Final Drainage Report

Windermere Filing No. 2 El Paso County, Colorado

PCD File No.: [PPR2442](#)

Prepared: November 2024

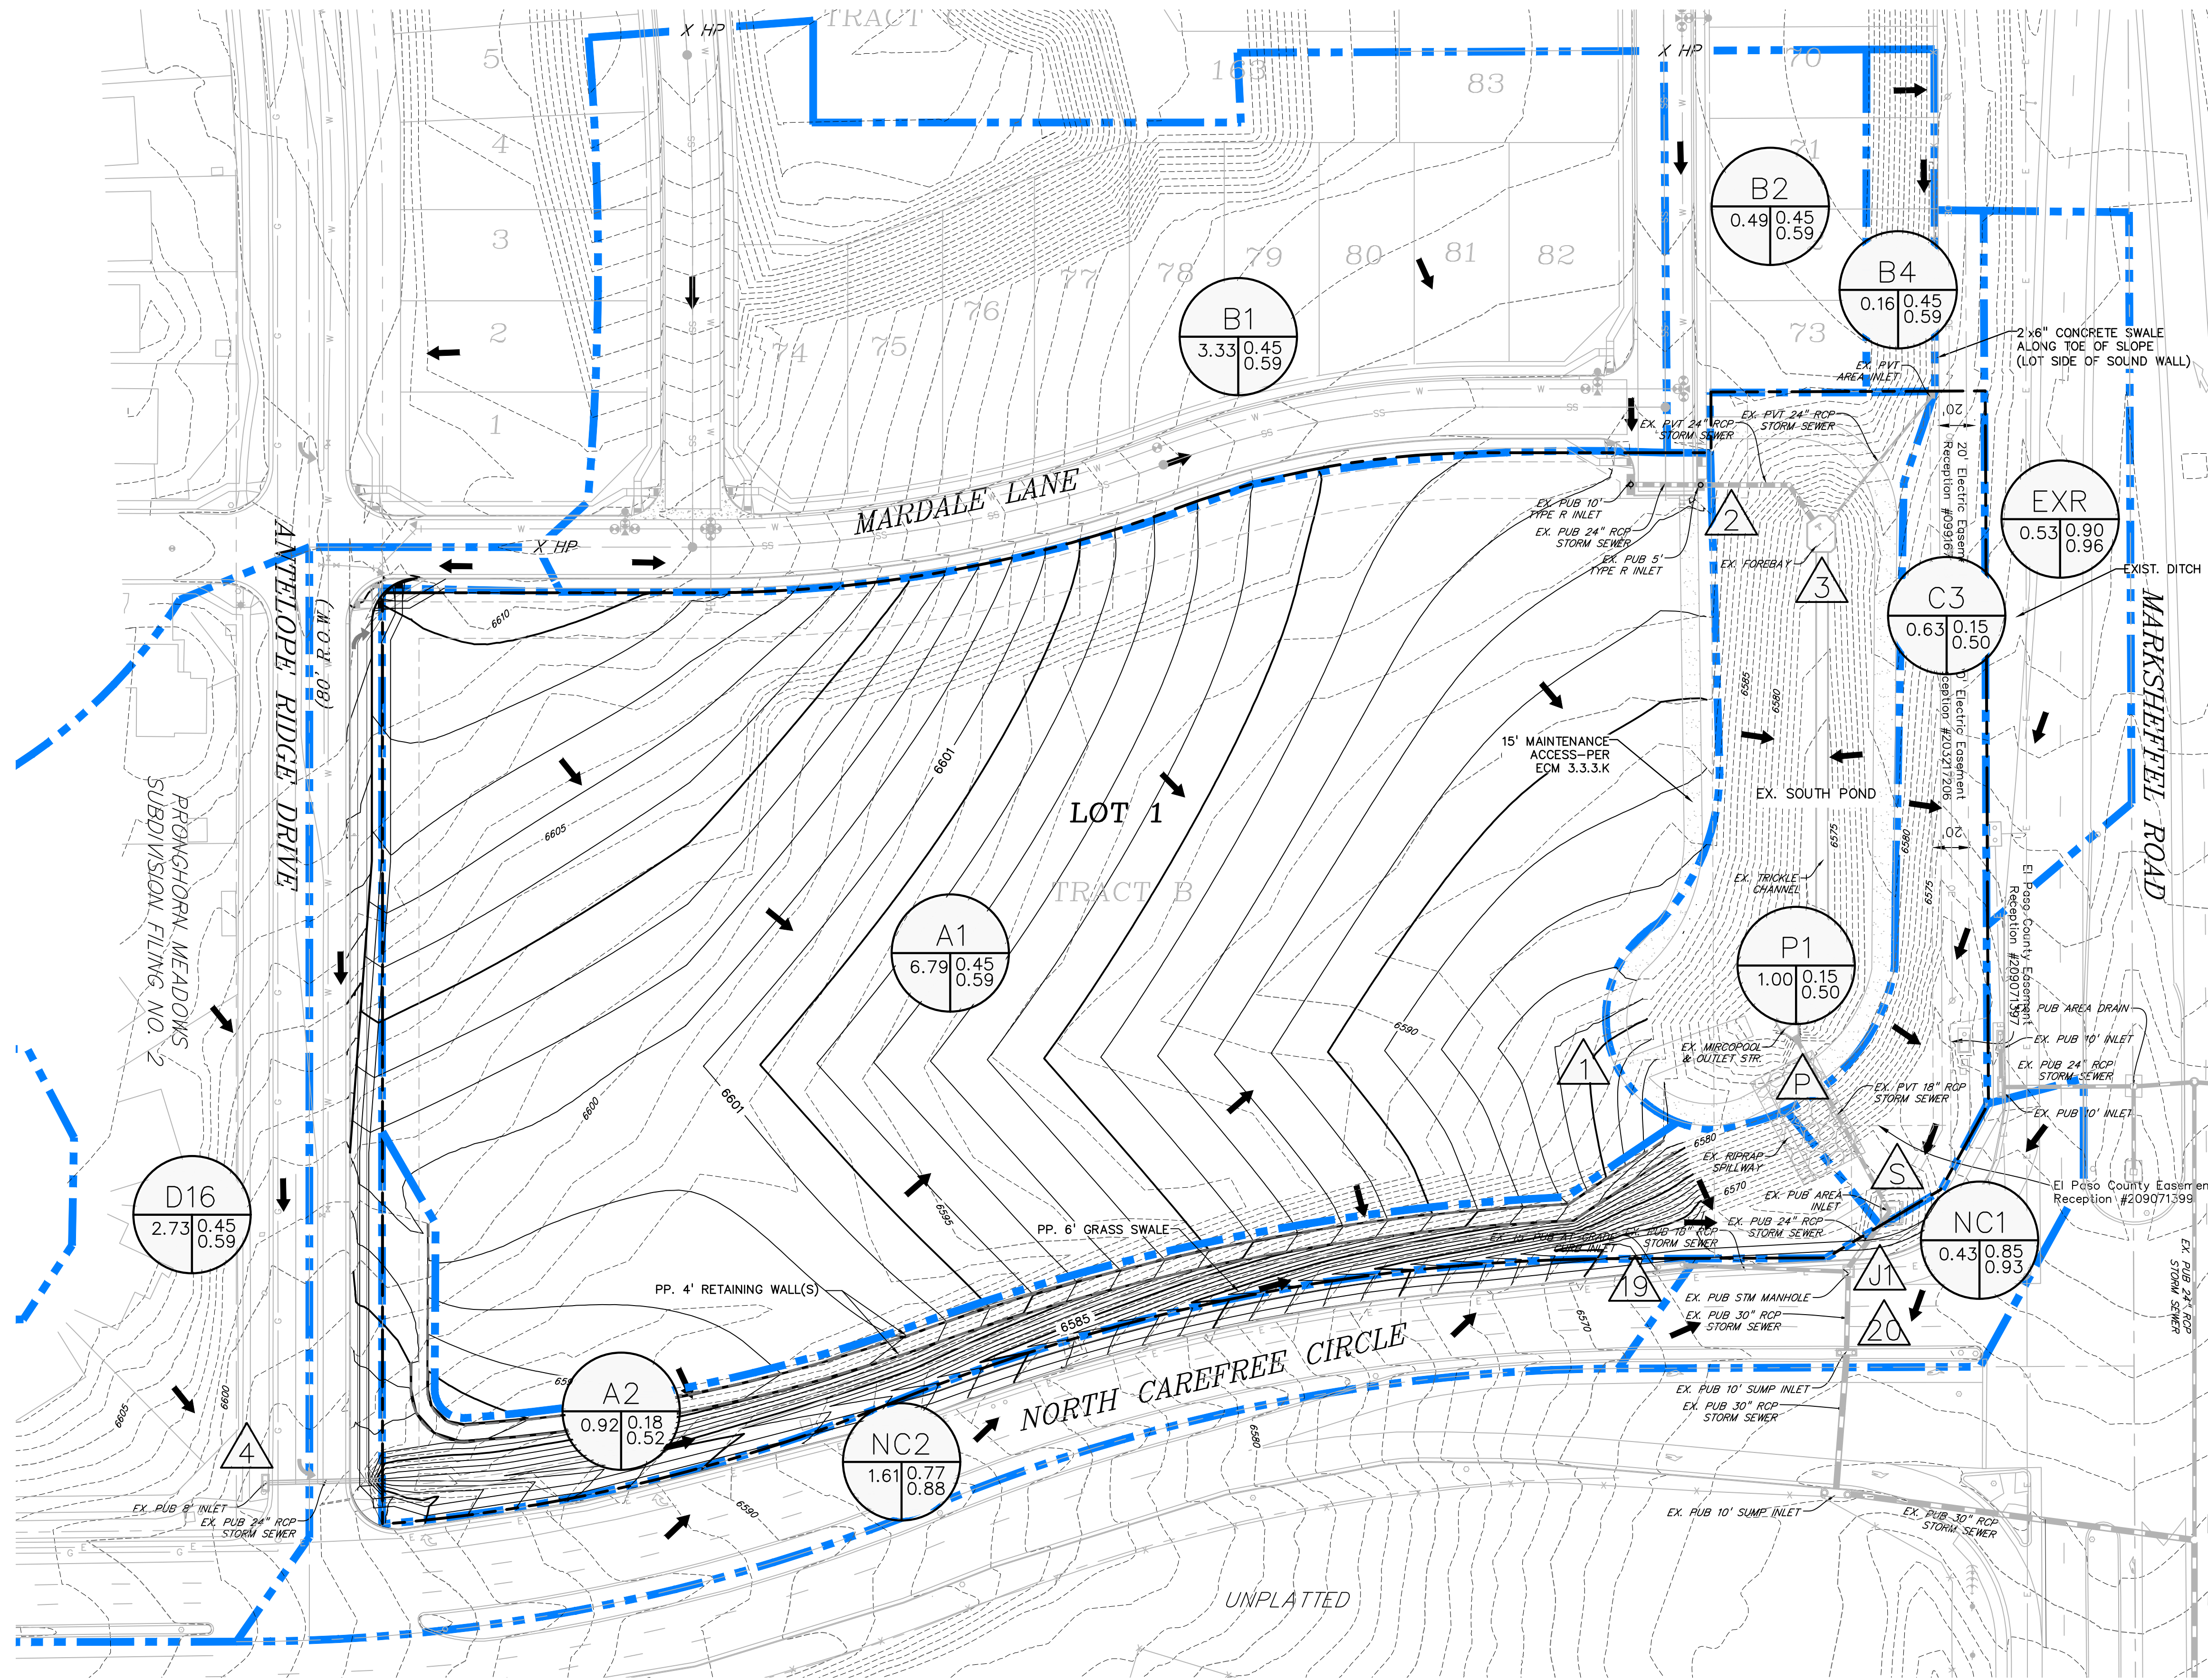
will review with next submittal

DR4

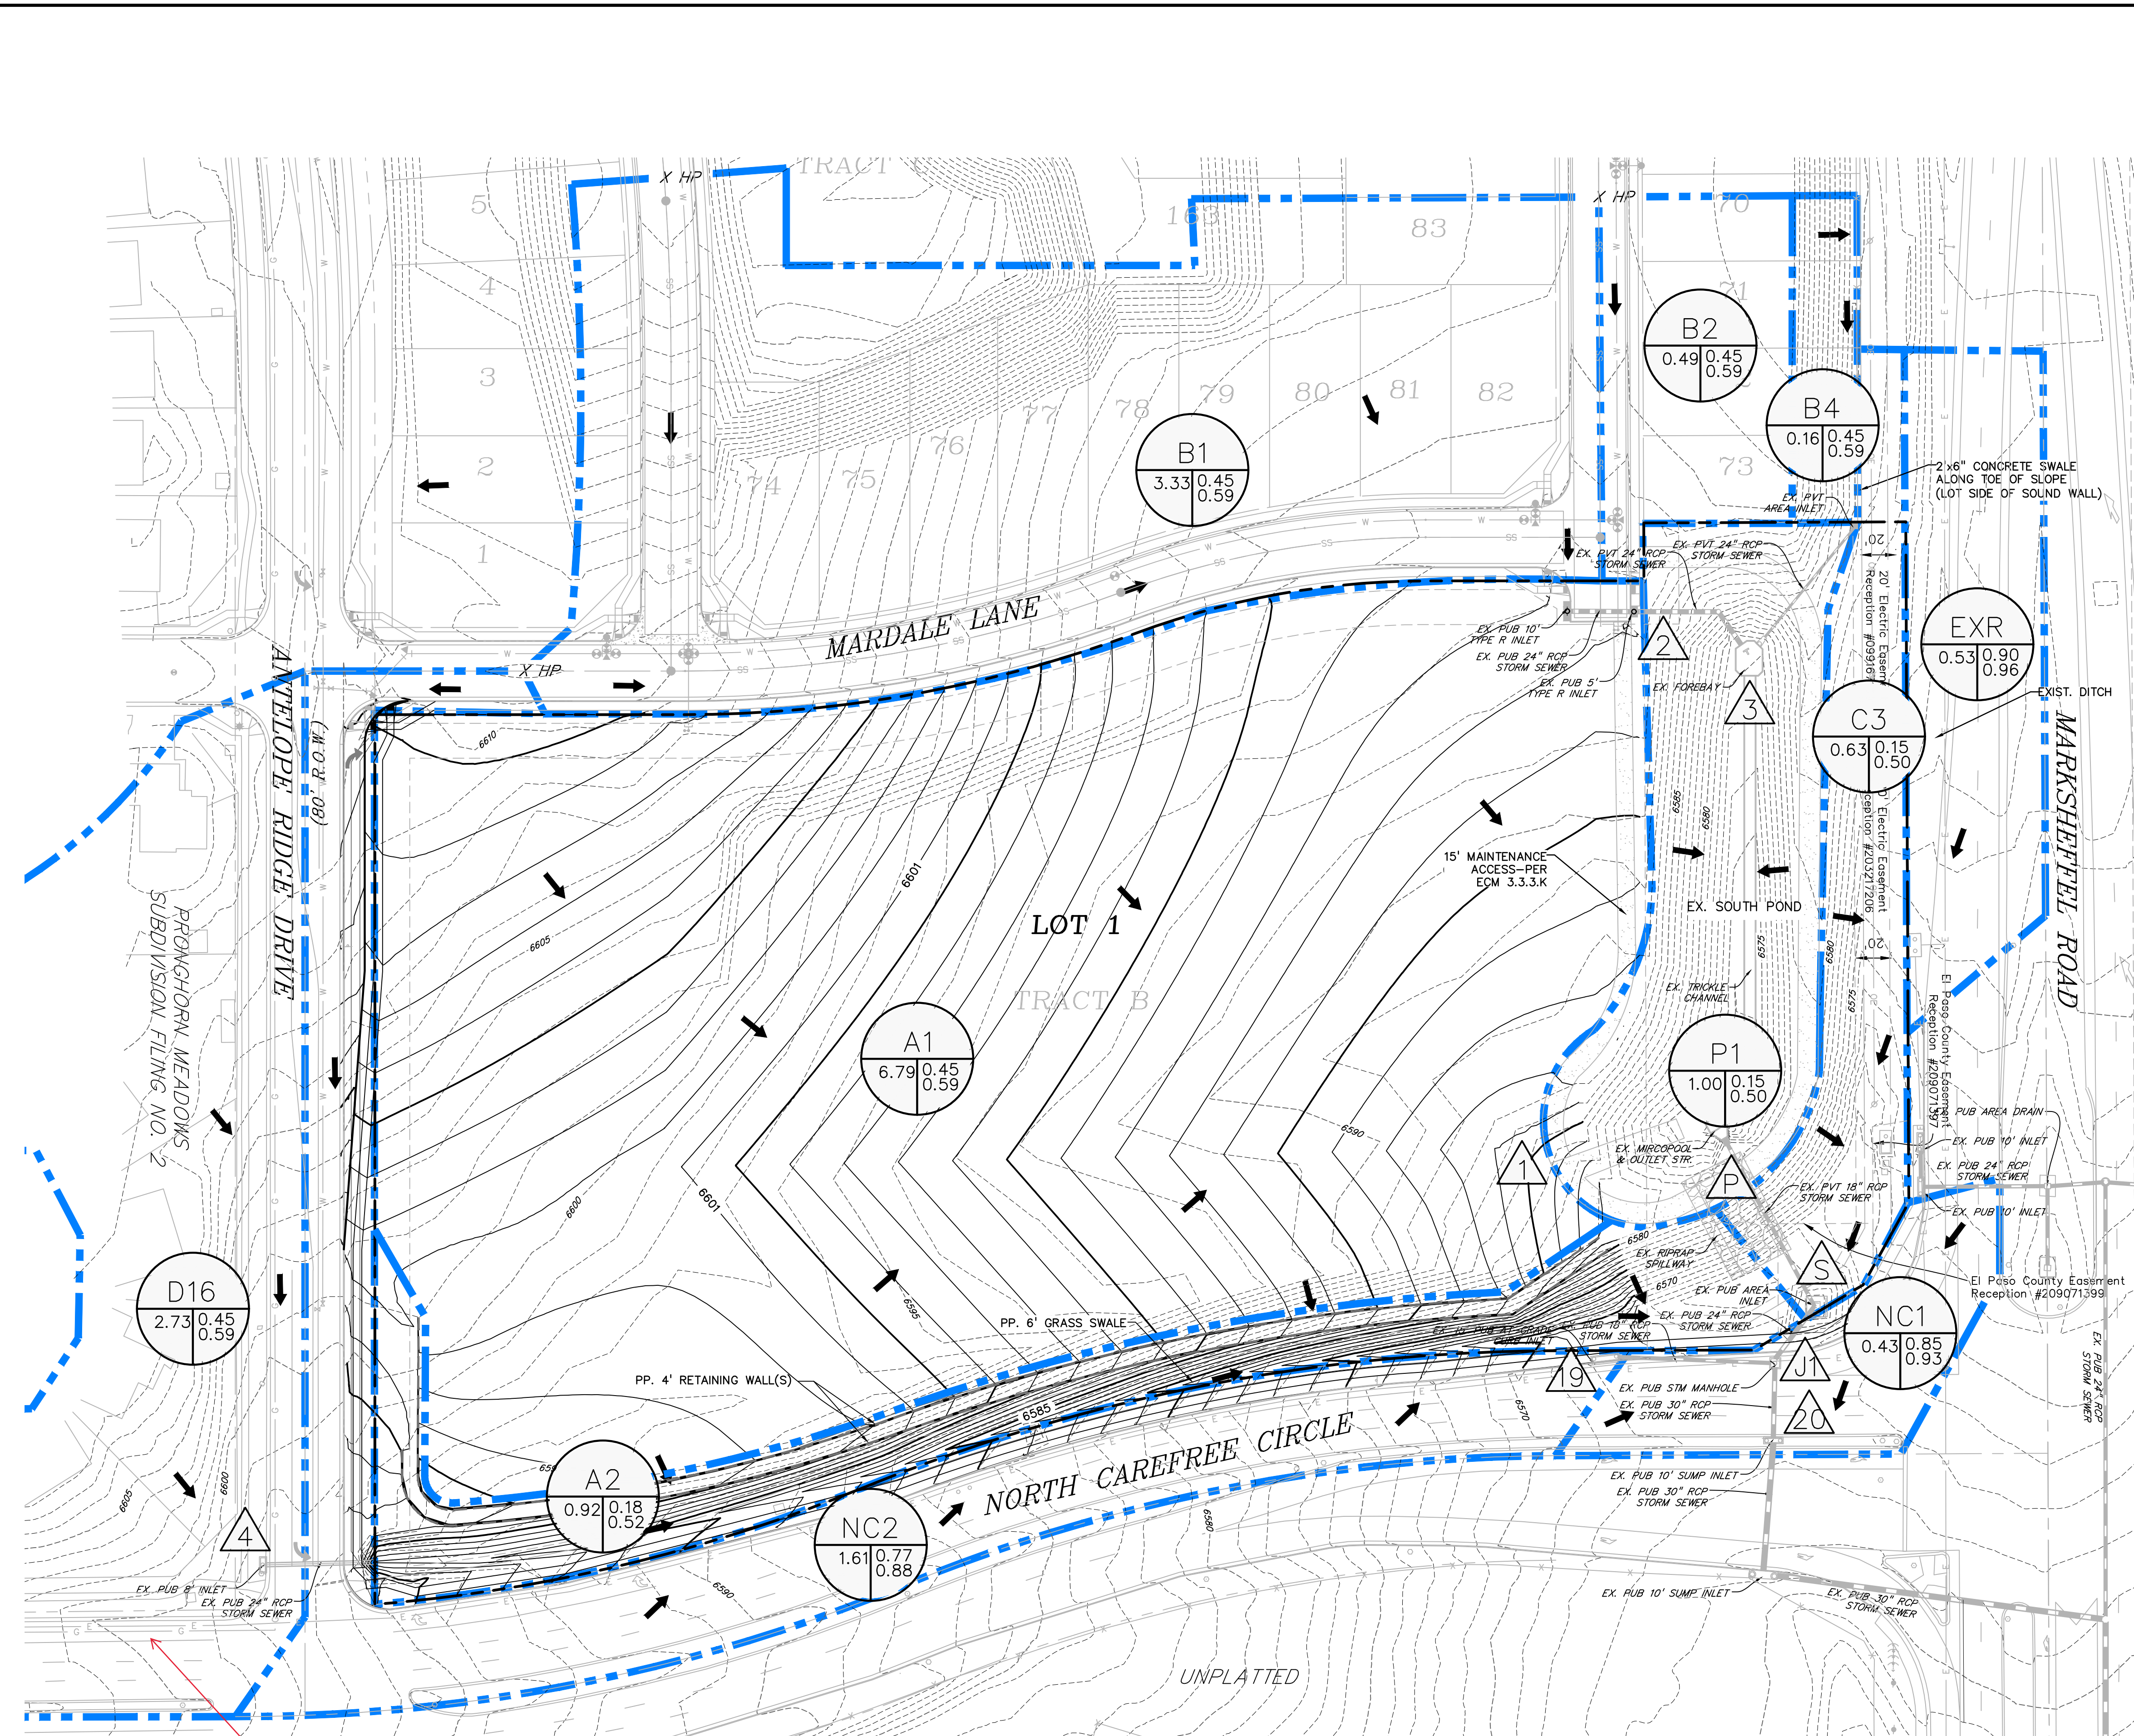
REFERENCE HISTORIC MAP FOR BASIN D16 EXTENTS
